**RECALL
BULLETIN:**
150625ARG

**PRODUCT(S)
AFFECTED:**
Fleetwood
Southwind

**MODEL(S)
AFFECTED:**
32 VS,
with
manufacturing
dates between
April 16, 2014
and
June 19, 2015

SUBJECT:
Providing
Egress for
Driver's Side
Bedroom
Window

Figure 1

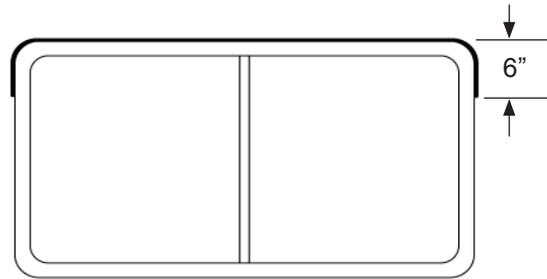
4. Install the new emergency egress window using the compression seal and screws supplied in the Recall kit. Apply a 1/8" bead of clear silicone sealant to the exterior upper six inches of the new window frame after installation. See Figure 1.
